Charlotte Department of Transportation

Memorandum

Subject: Rezoning Petition 15-063: Approximately 1.14 acres located on the north side of East Woodlawn Road between Park Road and Brandywine Road.

Figure 1

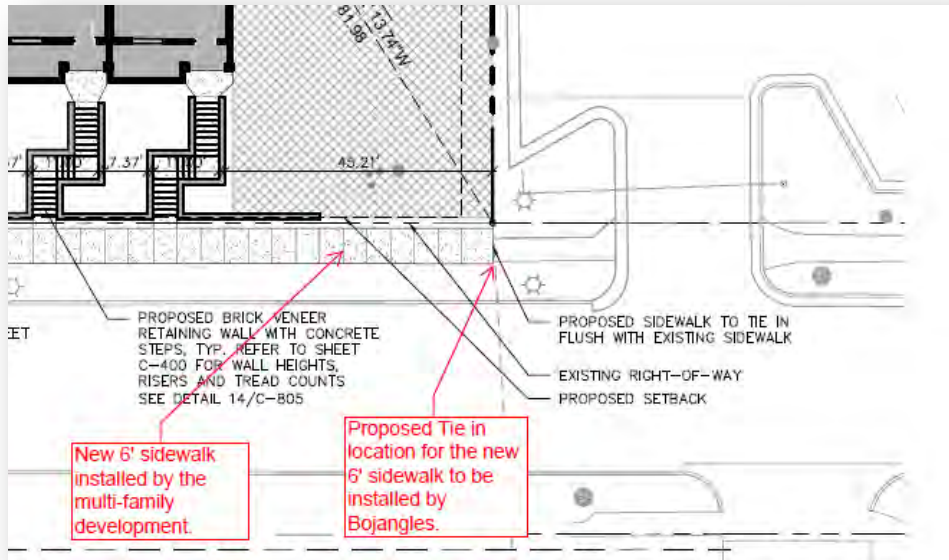
1. CDOT requests that the petitioner replace the existing 4' sidewalk and accessible ramps on the east side of the parcel along Summit Avenue with 6' sidewalk and accessible ramps (Figure 1 & 2). This sidewalk will provide pedestrian connectivity from W. Trade St. to the public sidewalk on Summit Avenue. See below the site plan of the adjacent multi-family development which is installing new 6' sidewalk up to parcel 071-016-14 (Bojangles):

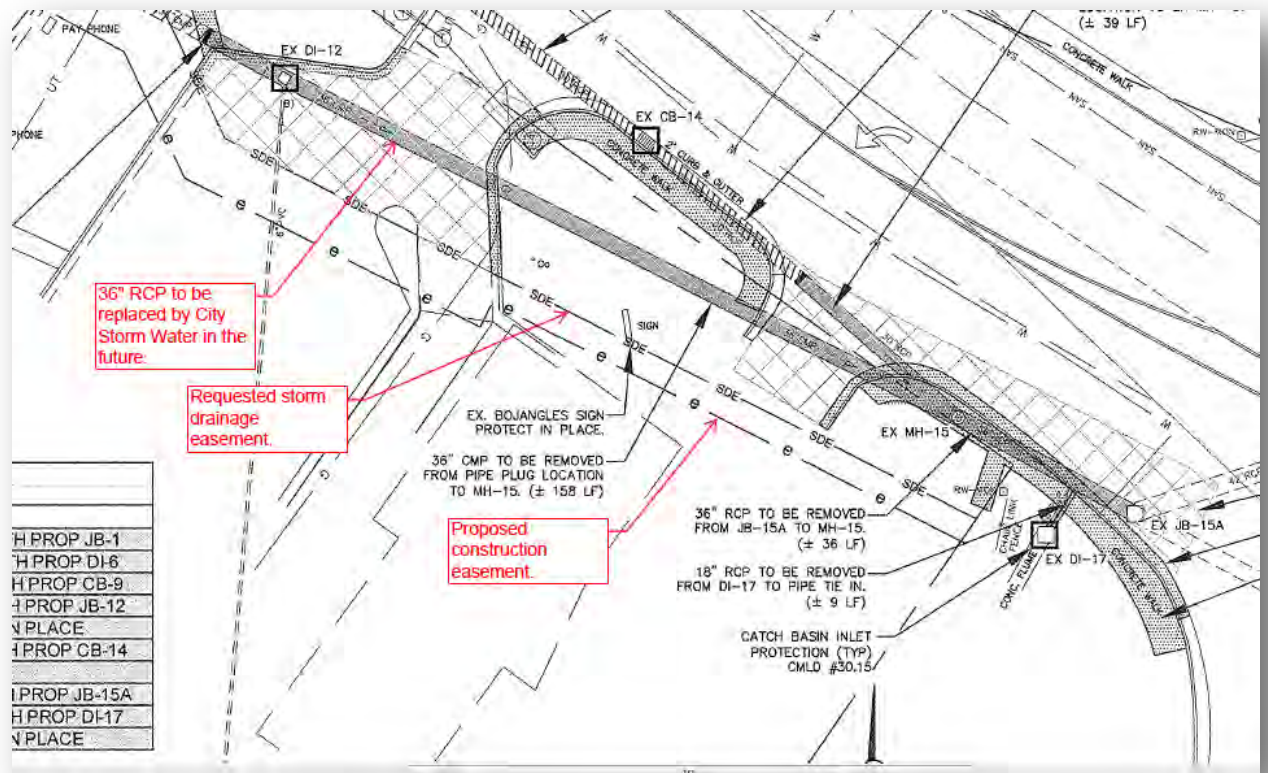
5. CDOT recommends that the petitioner dedicate the required storm drainage easement and construction easement as shown below for a storm water maintenance project that is upcoming. The petitioner should coordinate with John Keene (704-432-5216) with Storm Water Services to obtain the CAD file, which should be reflected on this site plan and the recorded plat.

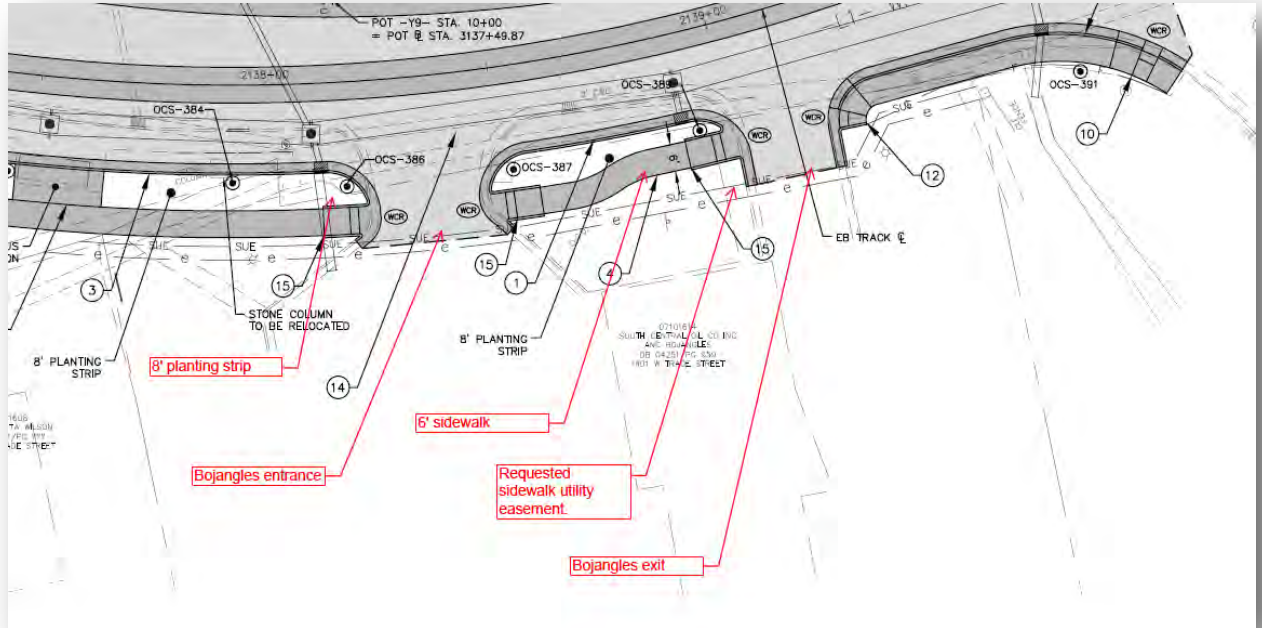
6. The Gold Line Streetcar Project will abut the front portion of this parcel. Please see the future roadway cross-section below from the actual plan set for the Street Car. CDOT requests that the petitioner dedicate the future sidewalk utility easements as shown on the

plan set. Please coordinate with Andy Widenhouse with CATS (704-432-0413) to obtain the CAD file to be shown on this site plan and the recorded plat.
